MPD answers to (pink and red) LBNC comments

Broad categories of questions

General 8c

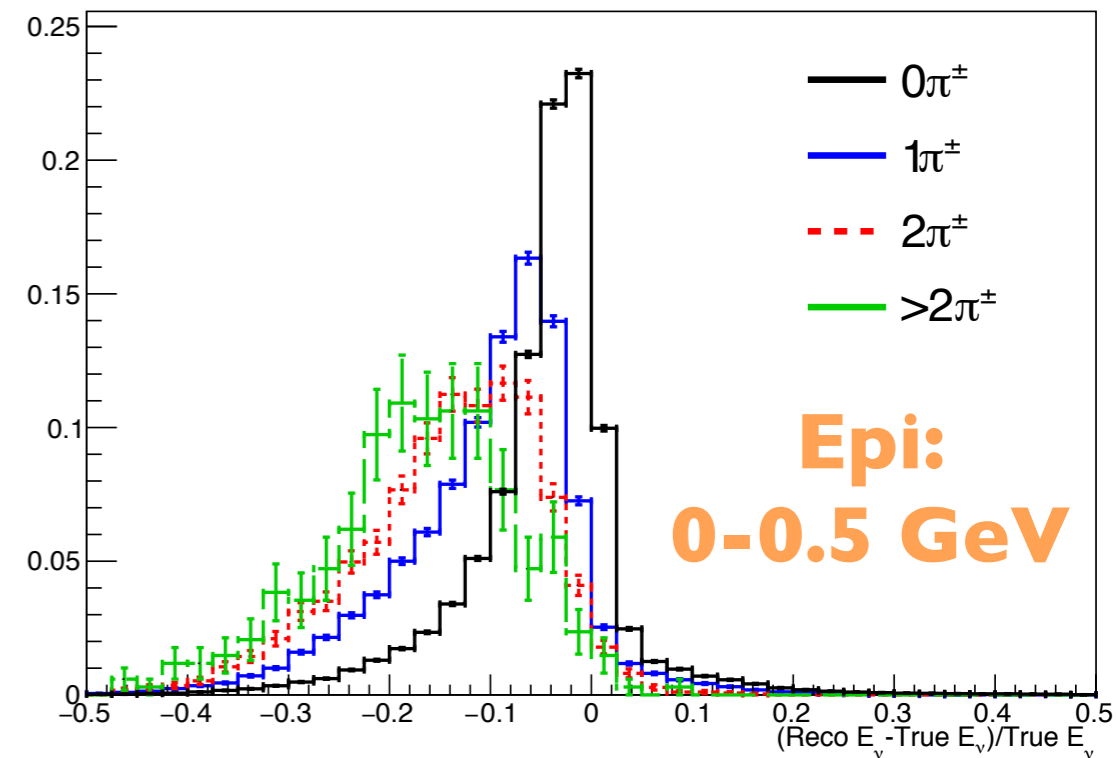
In many ways you argue for the MPD convincingly. However the arguments are mostly qualitative, not quantitative. Can you supply some concrete numbers which illustrate the gain from having this detector, with these particular capabilities?

- To be more specific about the proposed fake-data study with low-energy pions: this plot shows the relationship between true and reconstructed energy in the LAr for different charged pion multiplicities, when the total energy of all pions in the event is small (<0.5 GeV)

- The reco-true energy relationship depends strongly on the number of charged pions, especially when the pions are low energy.
- We also see that the dependence on pion multiplicity reduces for higher pion energies

- This could be because the reconstructed energy calculation does not include a correction for pion mass (it only considers energy deposited in the detector). In the far detector we will have to make such a correction, which will have an uncertainty due to pion multiplicity

- The MPD can measure pion multiplicity at lower pion energies than the LAr due to the lower thresholds, lower density of tracking material, and magnetic field, and inform the far detector correction

KE = 100 MeV, 60 modules, 100 - 400cm lever arm

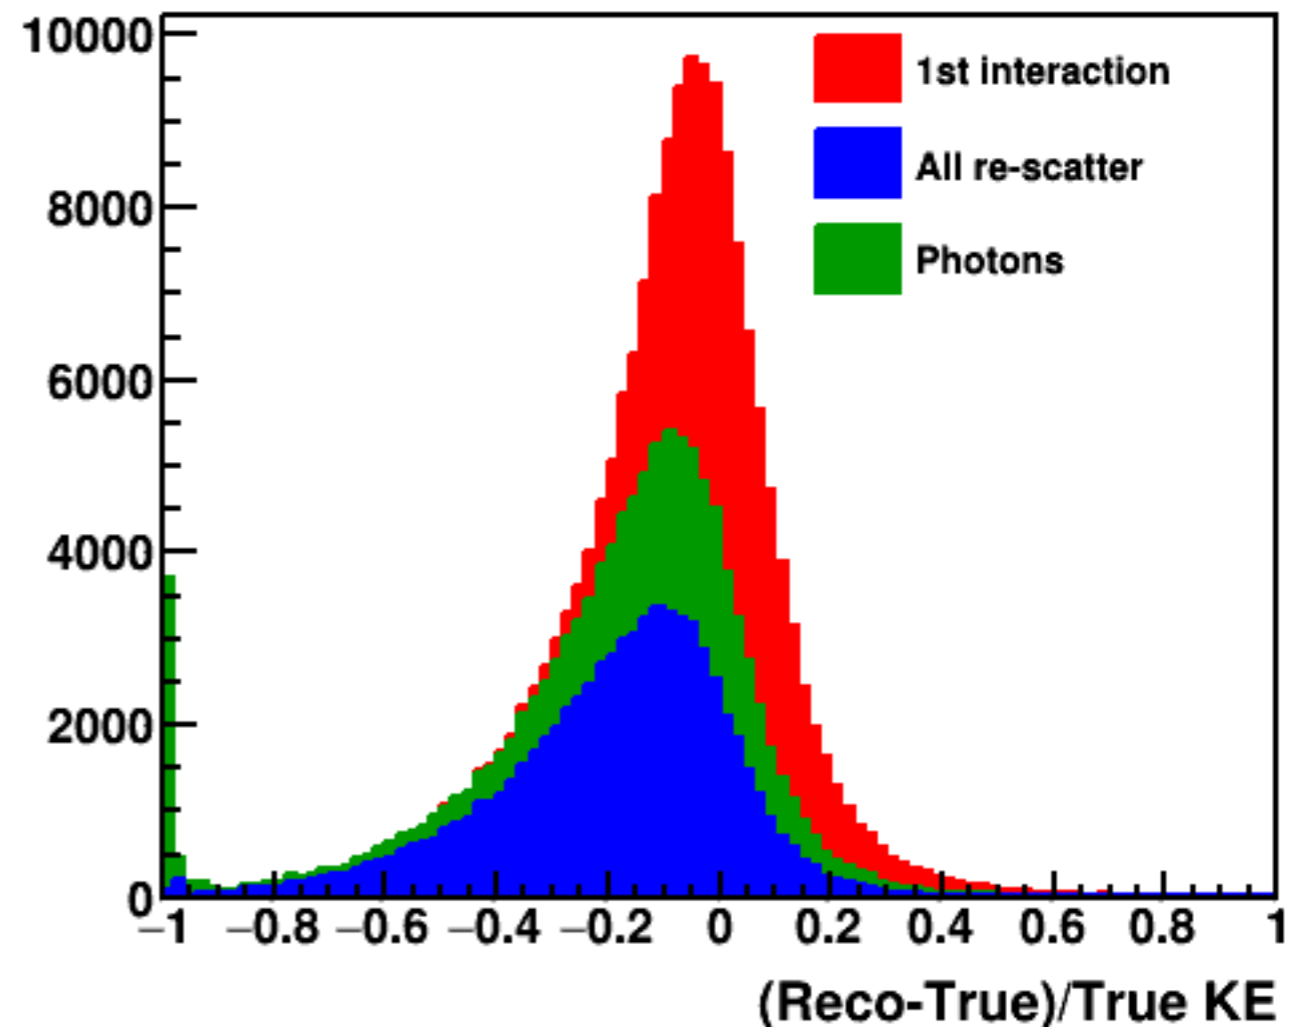
You give one number for the neutron efficiency in the document, of 60%, if I am not mistaken, but do not specify for which momentum range or acceptance. This makes it hard to judge whether or not this number is good or “bad”.

- This plot shows the relationship between reconstructed and true neutron energy for the three categories laid out above.
- Neutrons that are detected on their first interaction have almost no bias in the reconstructed energy
- When including neutrons that are detected after a re-scatter and by de-excitation photons, there is a $\sim 10\%$ bias in the reconstructed neutron energy.

General 8e

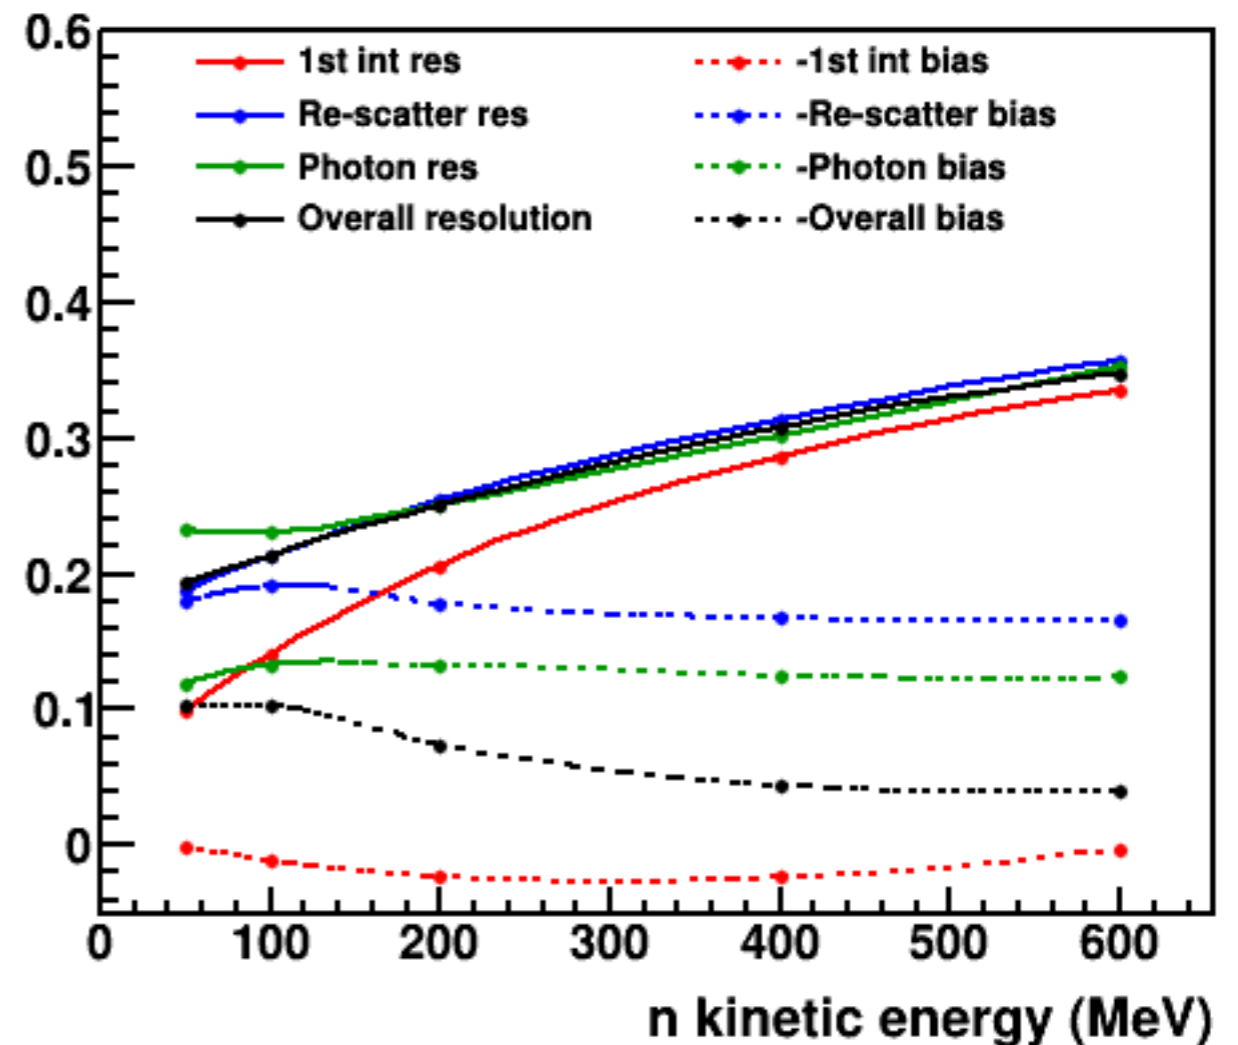
You give one number for the neutron efficiency in the document, of 60%, if I am not mistaken, but do not specify for which momentum range or acceptance. This makes it hard to judge whether or not this number is good or “bad”.

- This plot shows similar information:
 - the energy resolution and bias on the reconstructed neutron energy for the three different categories, and over all predicted neutrons
- Neutrons that are detected on their first interaction have almost no bias in the reconstructed energy, and a resolution of 10-30% depending on neutron energy
- When including neutrons that are detected after a re-scatter and by de-excitation photons, there is a ~10% bias in the reconstructed neutron energy and resolution of 20-35%

60 modules

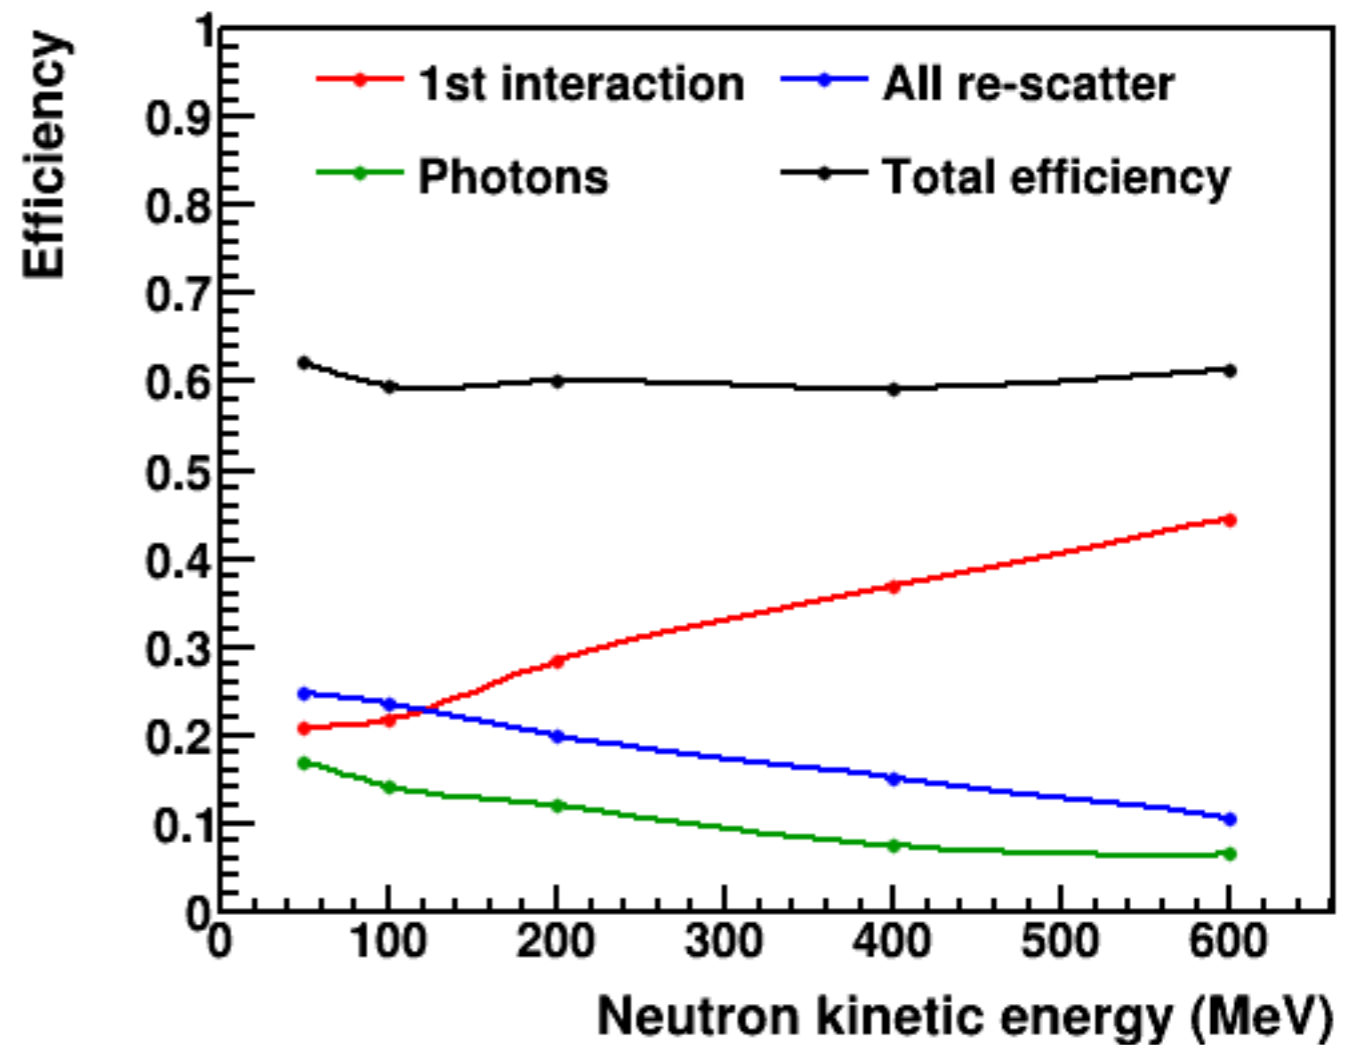
You give one number for the neutron efficiency in the document, of 60%, if I am not mistaken, but do not specify for which momentum range or acceptance. This makes it hard to judge whether or not this number is good or “bad”

- This plot shows the neutron efficiency as a function of energy for each of the categories described above
- The efficiency for detecting neutrons on their first interaction (i.e. with no reconstructed energy bias and good resolution) is ~20-40% depending on neutron energy
- The total efficiency for detecting all neutrons is ~60%, but that includes neutrons for which the reconstructed energy will have significant biases.
- Despite these caveats, this shows a huge increase in neutron reconstruction capability compared to other neutrino experiments (which largely do not have the capability to reconstruct neutrons)

Total neutron energy per event

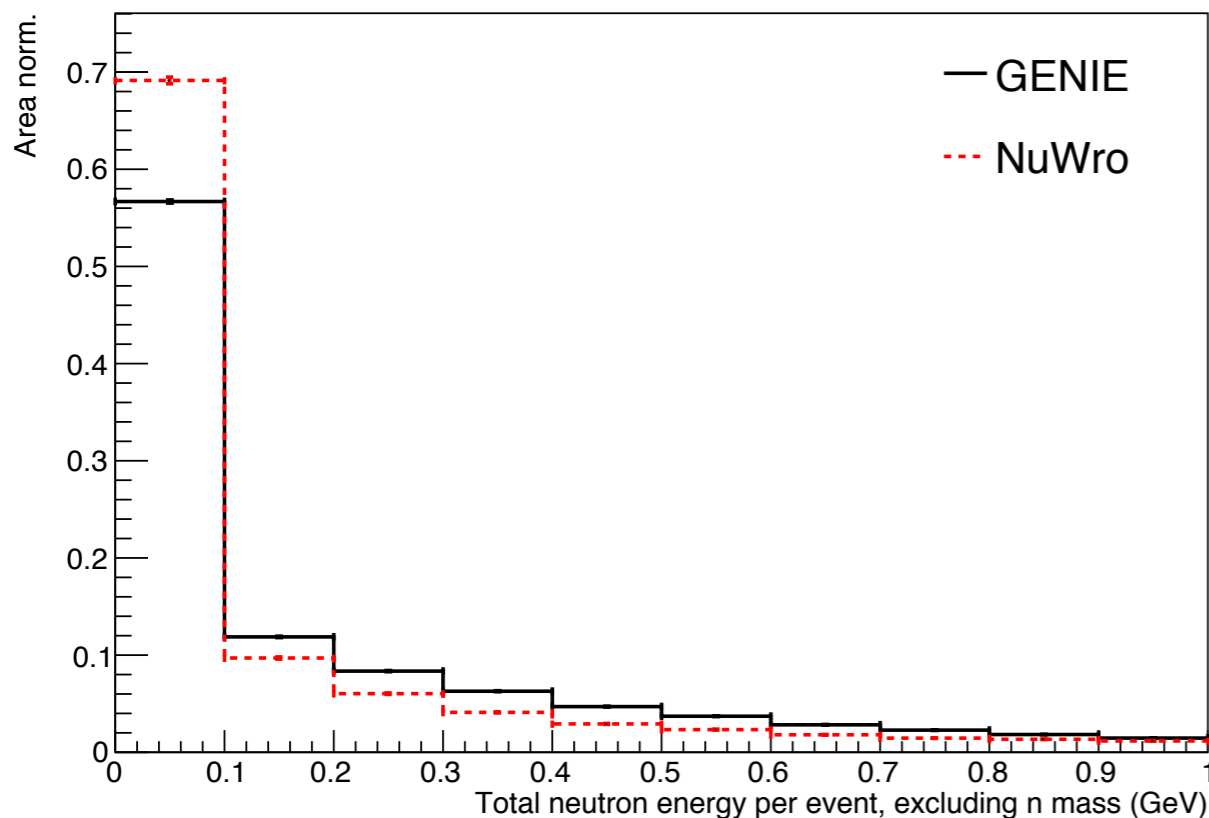
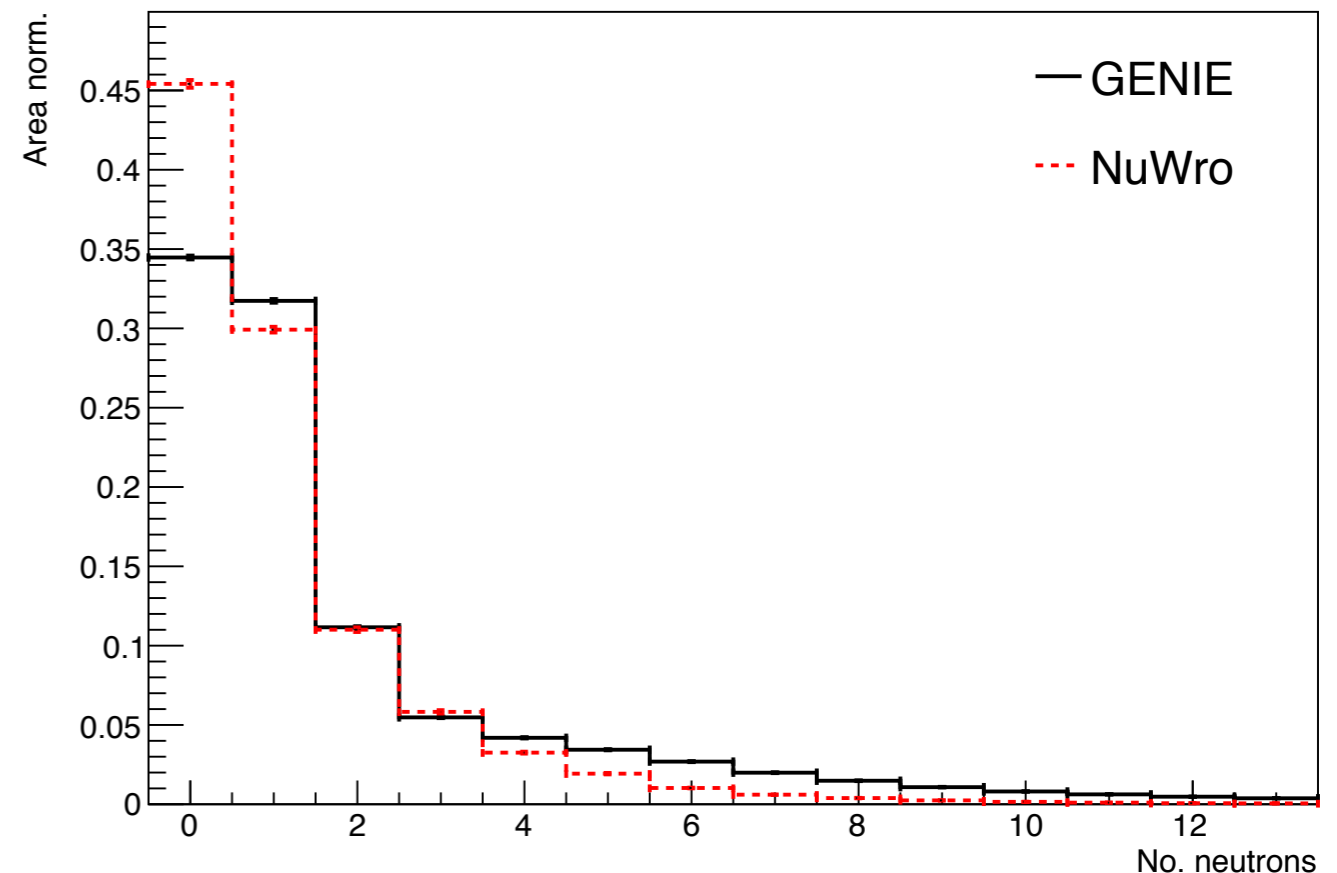
1-31: Is there a plot to show the energy carried by fast and slow neutrons? How much really MPD ECAL will help in recovering this missing energy. This is an important information and a little more explanation will help.

- In addition to the information shown on the previous slide, it should be noted that predictions of neutrons produced in neutrino interactions can differ significantly between generators, because there is very little data to inform them.
- Demonstrated in these plots: total number of neutrons and total neutron energy predicted per neutrino interaction from NuWro and GENIE.
